Access Compliance Report

Public Rights-of-Way

Intersection ID: 28035	Main Street: MITCHELL_GLEN_DR	Cross Street: KILPATRICK_LN	Location: SE
ADA ID: 450403B66879	Ramp Type: PerpDiag	Initial Pass/Fail: Pass	Overall Compliance: No
Severity Score: 17.5			
Codes/Mitigation Info/Possible Solution		Field Measurements/Component Compliance

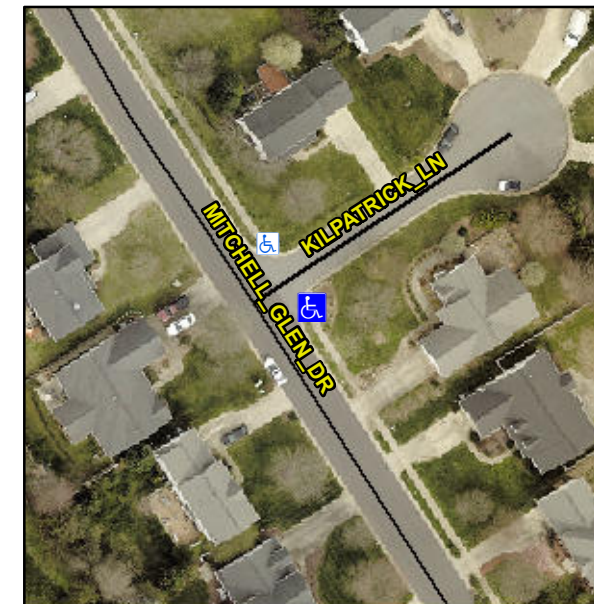
Remove & Replace Curb Ramp With Two New Directional Ramps or Equivalent. Remove & Replace Gutter.

R304.2.1, R304.2.2-Perp, R304.3.2-Para, R304.5.3, R305.1.4, R305.2, R304.5.4
